Milford Police Department
401 NE Front Street Milford, Delaware
Project No. 2019030.00
Bid Pac A – Contracts 1 thru 17
March 4, 2022

Addendum No. 2

Addendum No. 2 consists of:
RYJ Written directive (4 pages)
BMG Written directive (2 pages)
Construction Drawings (See BMG directive for list) (24 Drawings)

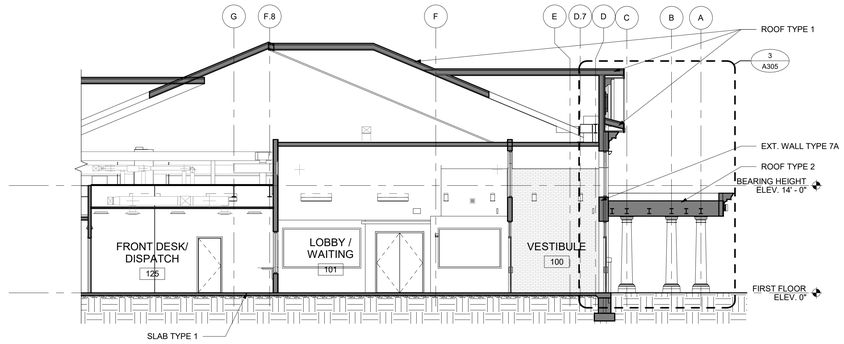
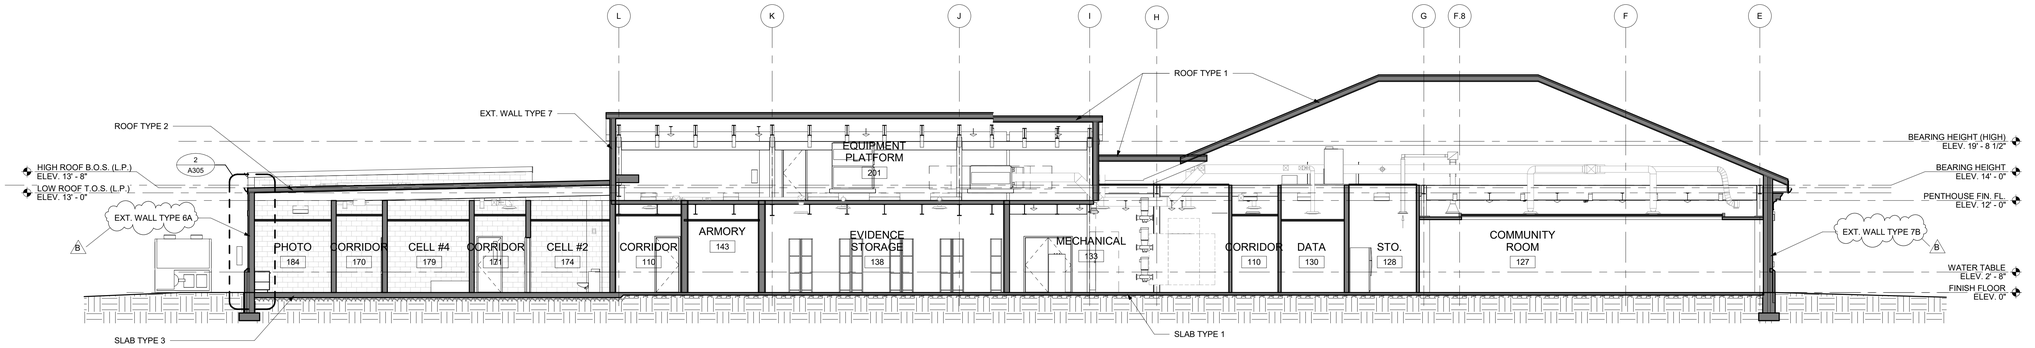
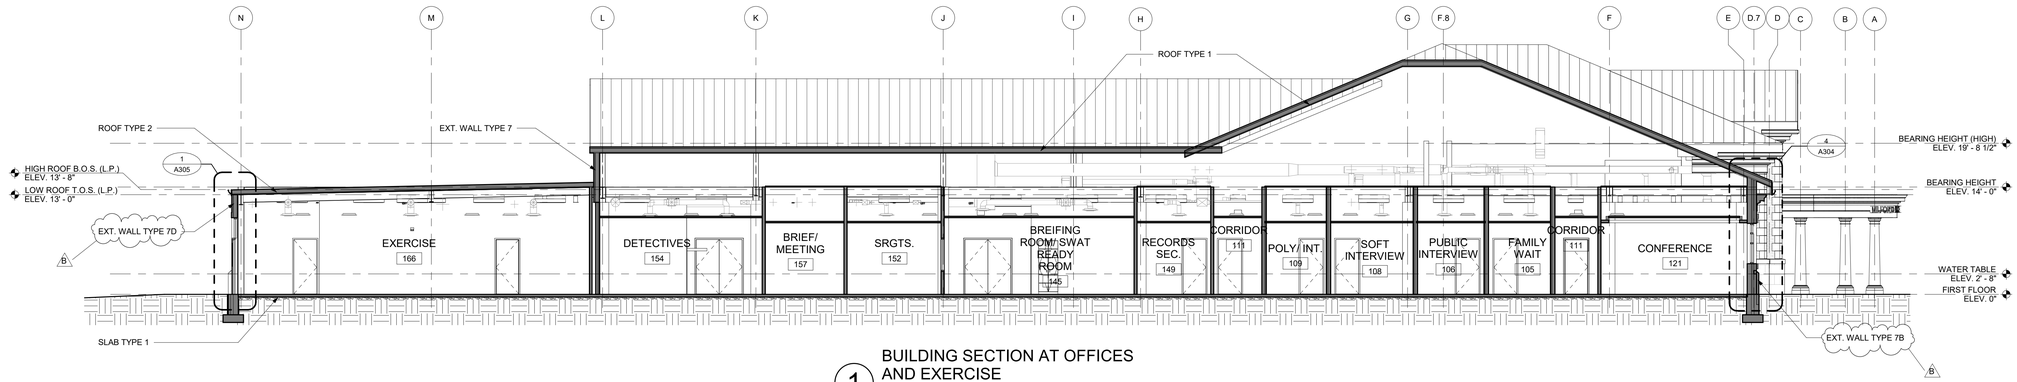
a. REVISE character lettering note
16. A301 – BUILDING SECTIONS
    a. UPDATE exterior wall types
17. A302 – BUILDING SECTIONS
    a. UPDATE exterior wall types

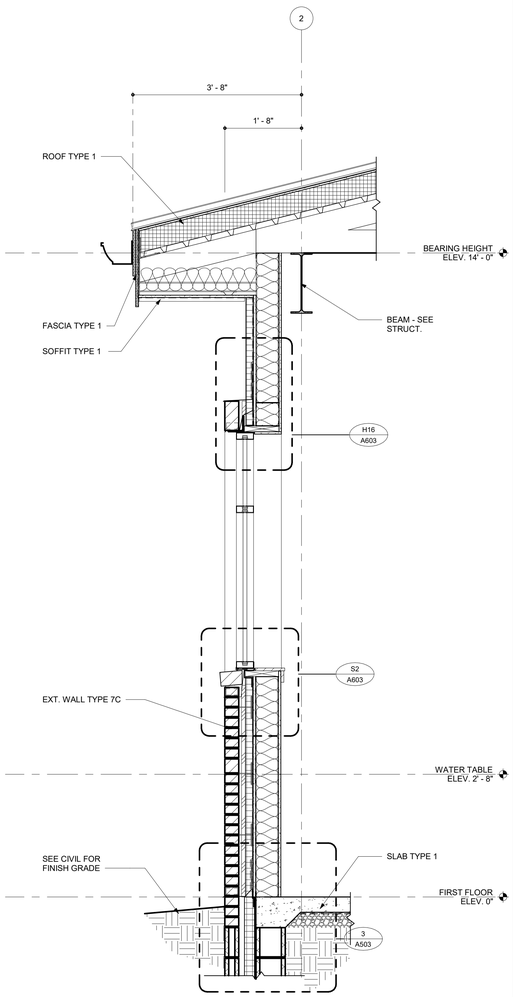
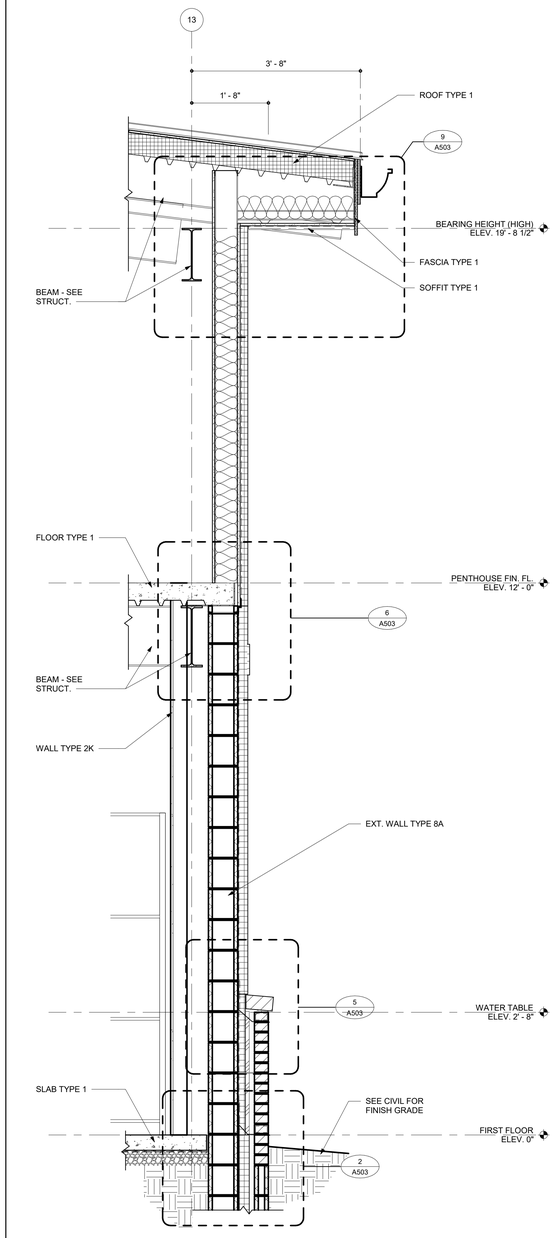
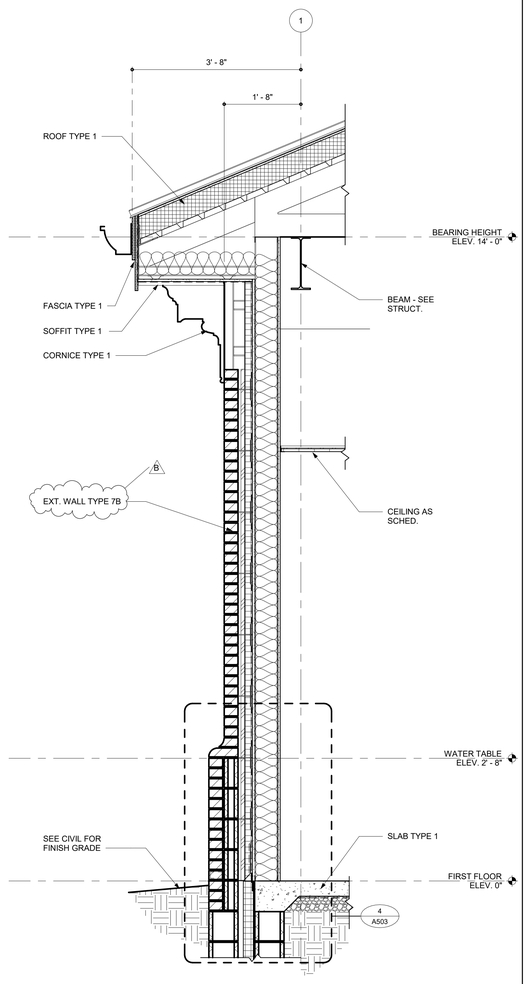
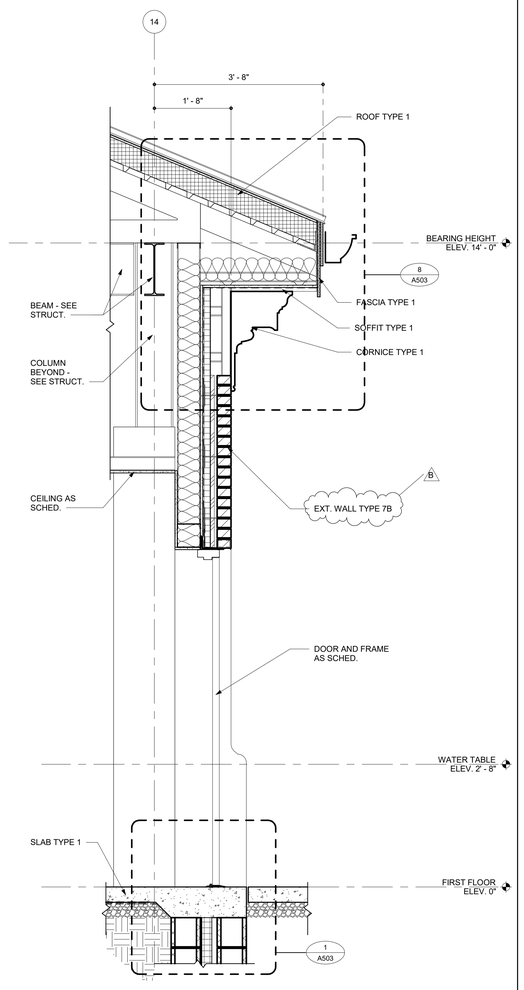
18. A303 – WALL SECTIONS
    a. UPDATE exterior wall types
19. A304 – WALL SECTIONS
    a. UPDATE exterior wall types
20. A401 – ENLARGED PLANS
    a. 2/A401 – ADD 'Lockers' note at Property Storage 182

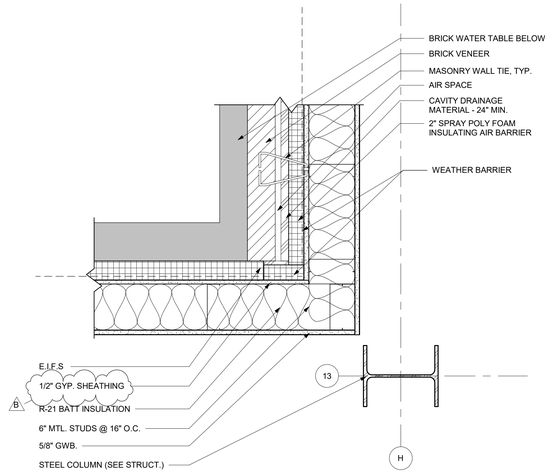
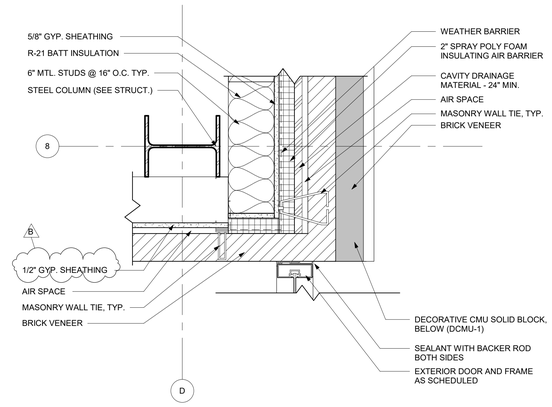
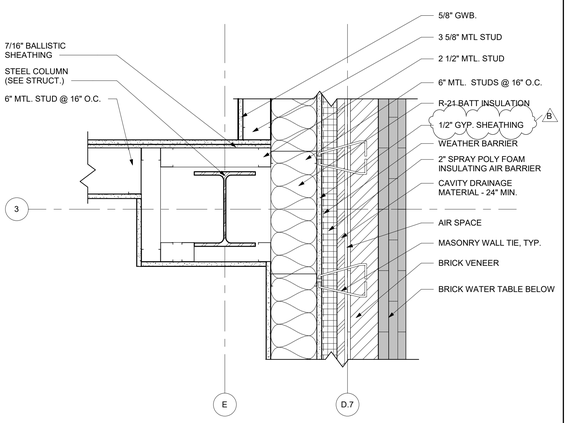
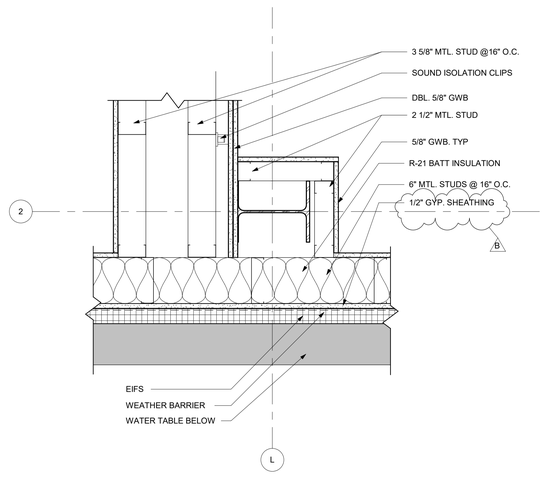
b. 5, 6/A401 – UPDATE dimensions of stair run and rise
21. A501 – PLAN DETAILS
    a. 3, 4, 5, 10, 11, 12/A501 – REVISE gypsum sheathing note
22. A502 – PLAN DETAILS

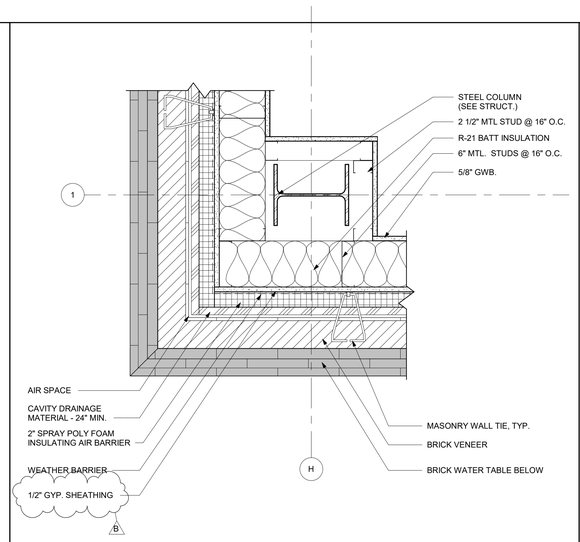
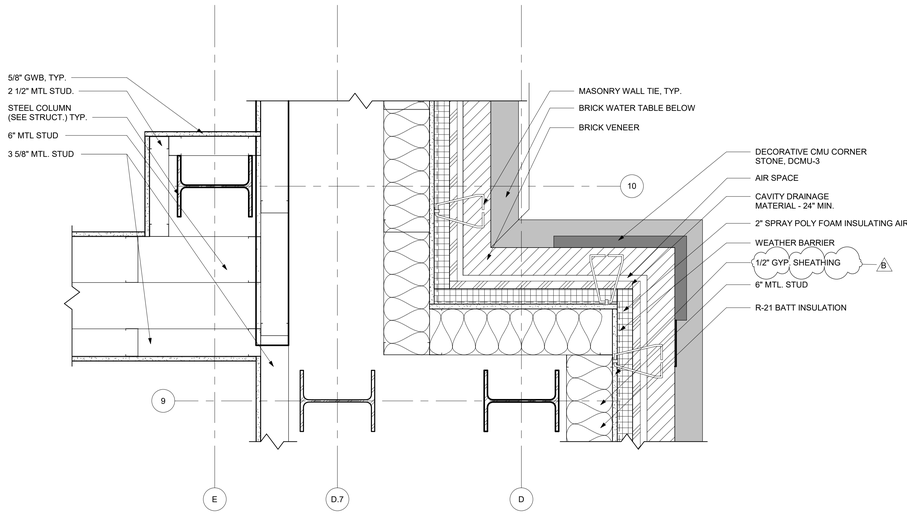
a. 2, 6/A501 – REVISE gypsum sheathing note
23. A503 – SECTION DETAILS
    a. 3, 4, 6 ,7, 9, 11/A501 – REVISE gypsum sheathing note
    b. 8, 11/A501 – ADD wd blocking per FRP manufacturer requirements
